6 November 2018 Revised: 20 March, 2019

Addendum 3

East Coast Hearing and Balance
Morehead City, North Carolina

UTILITY PLAN

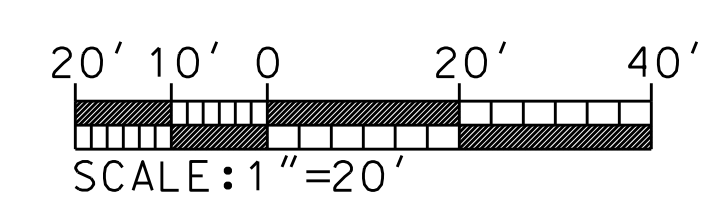
- ~~• The Bid Date has been revised to 20 November 2018 at 4pm.~~
- ~~• Base bid to include a full fire sprinkler system designed and installed by a NC Fire Sprinkler company. Sprinkler system to include water curtain sprinklers at all windows on rear wall. See attached revised Utility Plan with added 6" Fire Line, 6" RPZ Hotbox and tapping sleeve and valve. Provide electrical circuit to hotbox.~~

No.	BY	DATE	DESCRIPTION
1	CMC	11/5/18	ADD 6\"/>
